Central Planning Authority

Agenda for a meeting of the Central Planning Authority to be held on January 22, 2020 at **9:30 a.m.** in the Conference Room, 1st Floor, Government Administration Building, Elgin Avenue.

CPA/02/20

List of Applications Presented at CPA/02/20

Figure 1. Site Location and Environmental Context Plan

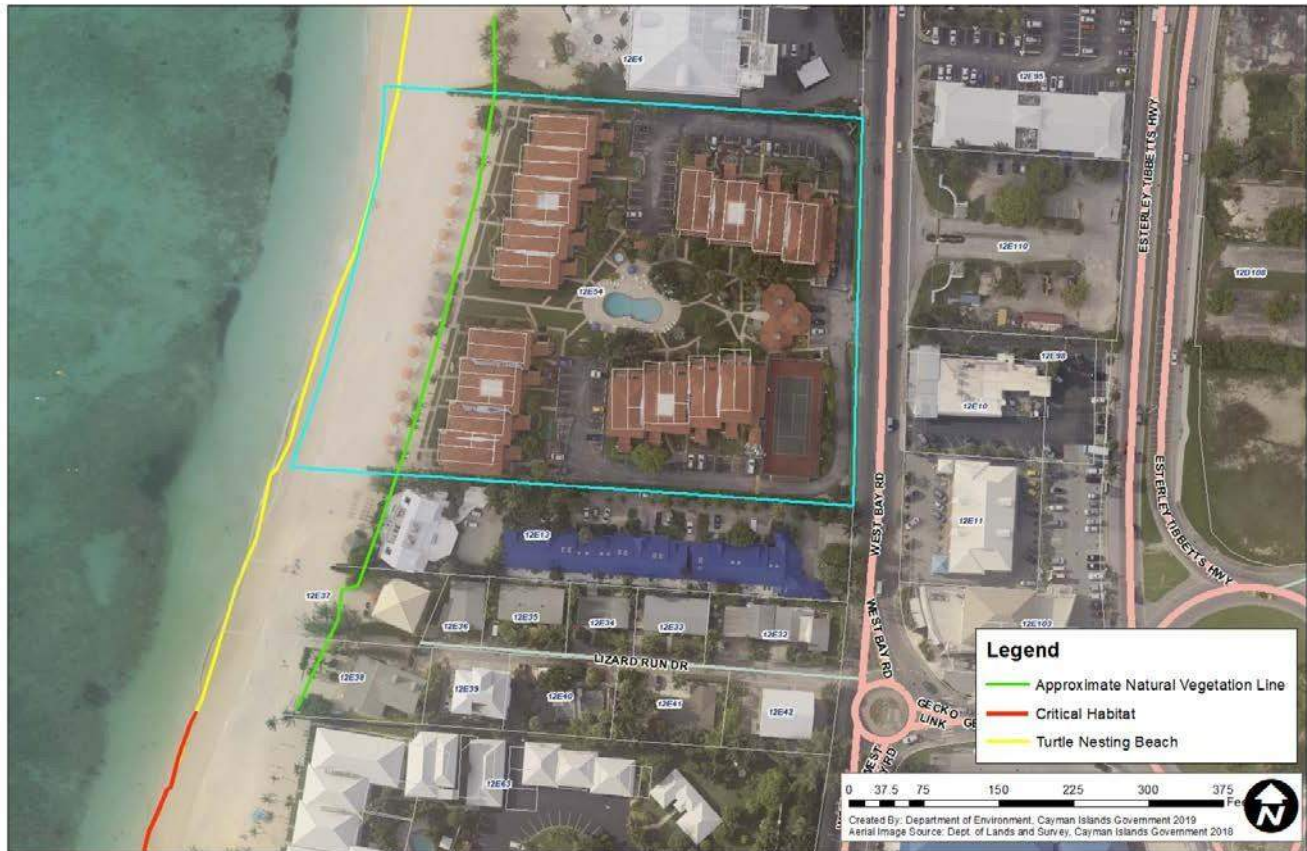
The application site is man-modified and is occupied by the existing Lacovia Condos. The site is adjacent to a Marine Protected Area (Seven Mile Beach Marine Park) and is located on a turtle nesting beach; approximately 260 ft from Critical Turtle Nesting Habitat under the proposed Sea Turtle Conservation Plan. Based on DoE’s 20 years of monitoring sea turtle populations, the site has had a number of nests from both loggerhead (Caretta caretta) and green (Chelonia mydas) sea turtles.

Climate Change and Coastal Setbacks: Climate change predictions for the region include increased storm intensity, storm surge, sea level rise and beach erosion over time which are likely to negatively impact the Cayman Islands including this site. Therefore it is important to have mitigation measures in place to provide resilience to the impacts of climate change. Thus, the Department is encouraged to see that the applicant is maintaining an appropriate setback (130 ft from the Mean High Water Mark), along with a cistern, a first floor slab at 15 ft above mean sea level, using native species for landscaping and no fire lane on the beach side. The Landscape Plan includes native species such as Sea Grape, Native Inkberry, and Bay Cedar, particularly in the dune plantings on the beach. Native species are naturally adapted for the environs and are cost effective and attractive planting options. With the

Turtle Nesting: *The site is a turtle nesting beach and all marine turtle species are listed in Part 1 of Schedule 1 of the National Conservation Law, 2013 as being 'protected at all times'. Therefore, to prevent heavy machinery destroying nests and to minimise the threat of artificial lighting on nesting and hatchling sea turtles we strongly recommend the inclusion of the below conditions in any grant of planning approval:*

- 1) The applicant shall prepare and submit a plan to the Department of Environment for turtle friendly lighting, which minimises the impacts on sea turtles. All lighting shall be installed in accordance with the plan, to be approved by the DoE. Guidance on developing a lighting plan can be found in the DoE's Turtle Friendly Lighting: Technical Advice Note (September 2018).*

Figure 1: DoE's 2013 Habitat Map showing Application Site (outlined in light blue)

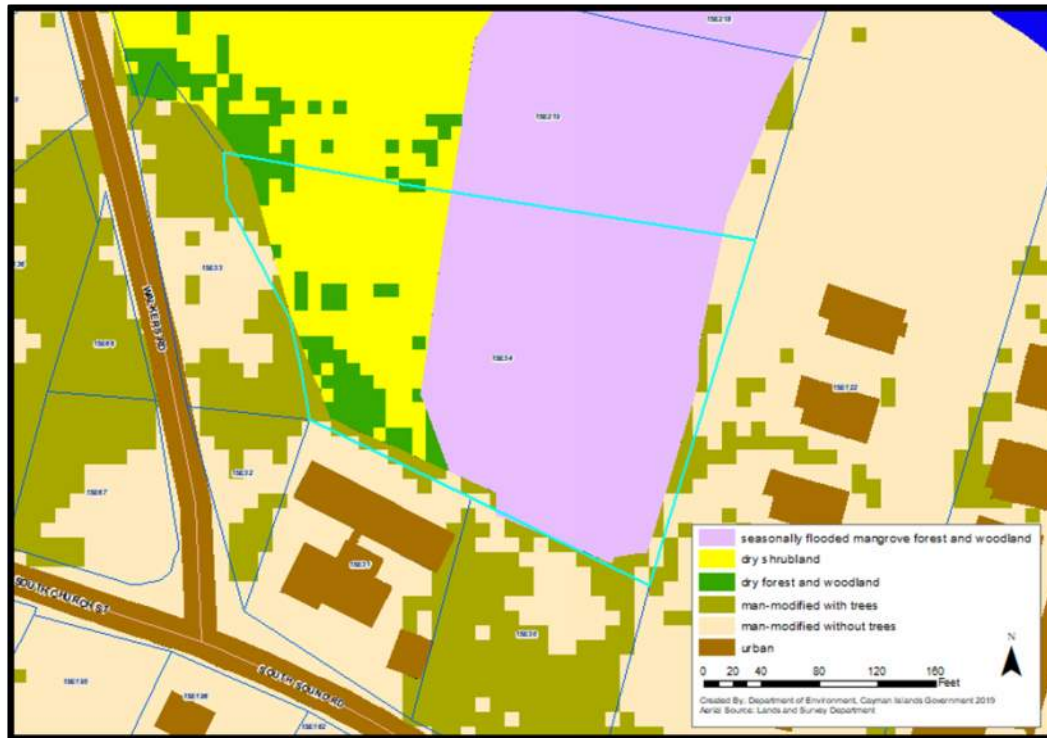
The application site was previously primarily dry forest and seasonally flooded mangrove forest, as showing in Figures 1 and 2. In July 2018, the Department reviewed an application for LIV Development for a 15 lot subdivision on Blocks 219 and 34 (Planning Ref: P18-0428). During the consultation for the application, the Department highlighted that parcel 15E34 was cleared without planning permission, thus reducing the ecological importance of the site. “

Figure 1: DoE's 2013 Habitat Map showing Application Site (outlined in light blue)

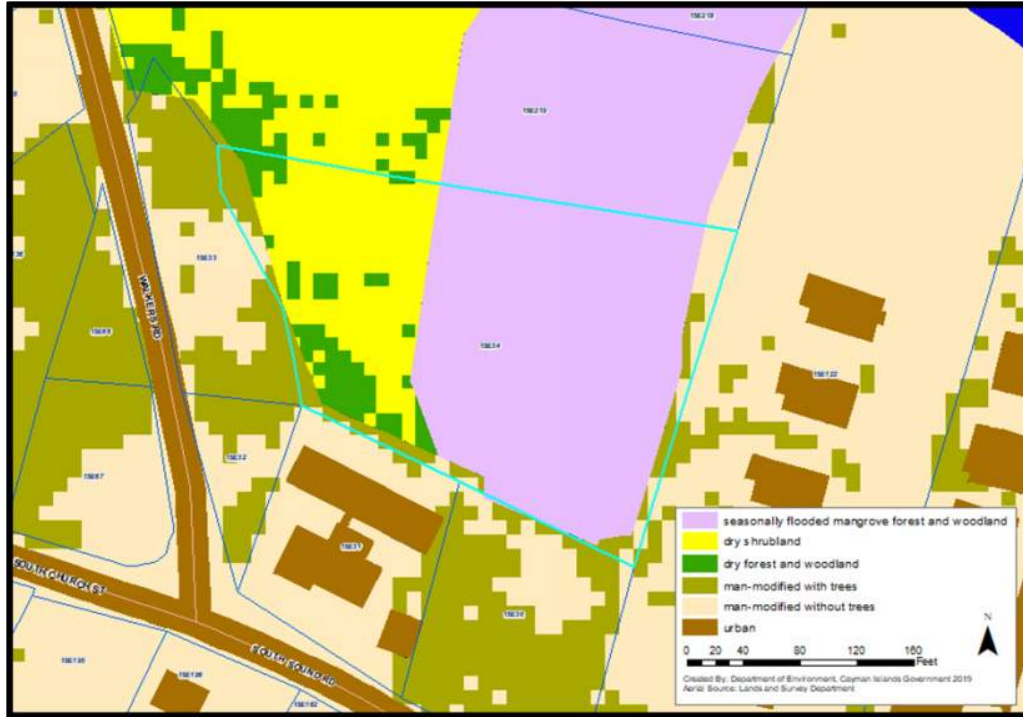
The application site was previously primarily dry forest and seasonally flooded mangrove forest, as showing in Figures 1 and 2. In July 2018, the Department reviewed an application for LIV Development for a 15 lot subdivision on Blocks 219 and 34 (Planning Ref: P18-0428). During the consultation for the application, the Department highlighted that parcel 15E34 was cleared without planning permission, thus reducing the ecological importance of the site.”

FIGURE 1: Plan extract overlaid on LIS 2013 aerial imagery to show proposed location in relation to existing rocks and the mean high water mark (source: Abernethy & Associates LTD. July

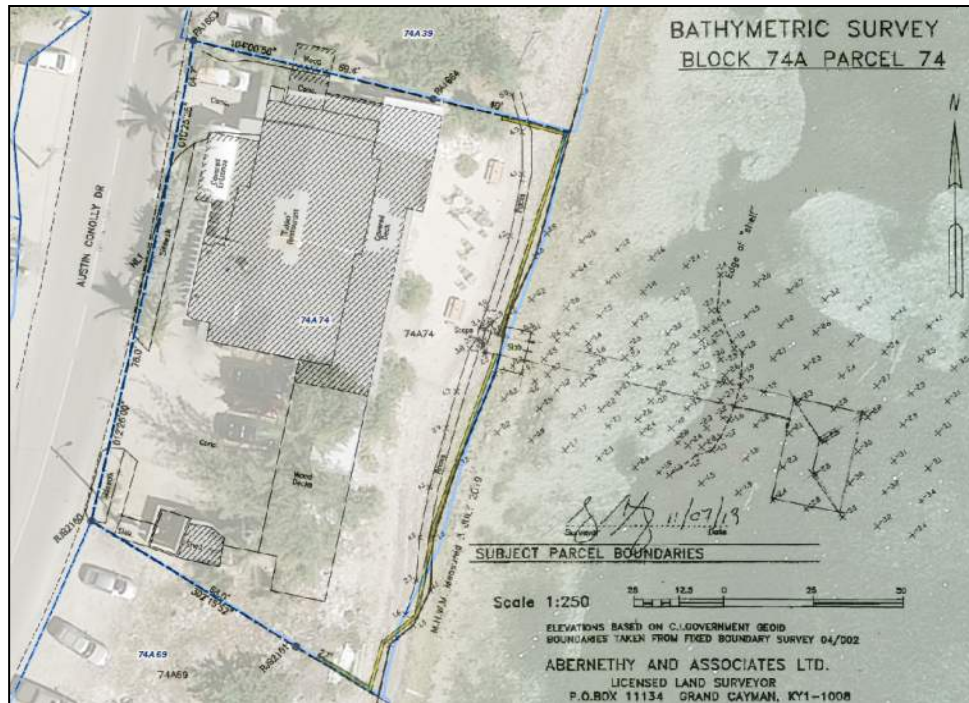
The applicant proposes the construction of a seawall at or immediately behind the Mean High Water Mark, recently surveyed in July 2019 (Figure 1). The Department of Environment (DOE) maintains its position that the placement of seawalls and other forms of hard engineering shore armoring on active beaches or close to the water's edge are usually problematic for a number of well documented reasons:

FIGURE 2: The existing rock wall on Block 74A Parcel 74 in relation to the sea (Source: DOE 22 August, 2019).

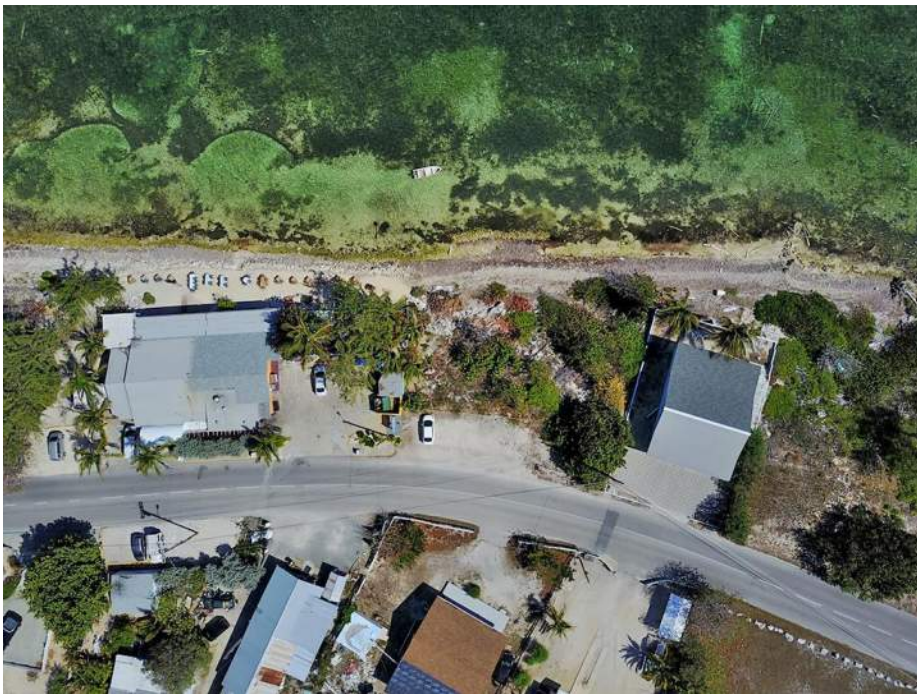
- ii. *The Department has conducted a number of site visits to the location and undertaken a pre application meeting with the applicant and the architect to better determine the circumstances for the application. During the site visit it was evident that efforts had already been undertaken to armour the shoreline through the construction of a low, boulder and cement, rip rap style sea wall (Figure 2). Behind this wall local beach sand had been placed on site to make a usable beach on which additional tables and seating for the restaurant were situated. The applicant indicated that the current low stone wall was not sufficient to keep larger less frequent storm waves from overtopping the wall and washing away the sand, leading to an ongoing maintenance issue. A higher concrete wall would reduce the overtopping for milder storm events but could not eliminate this risk in its entirety. A periodic placement of beach sand would still be required, albeit less frequently. The source of local beach sand is an additional off-site impact.*
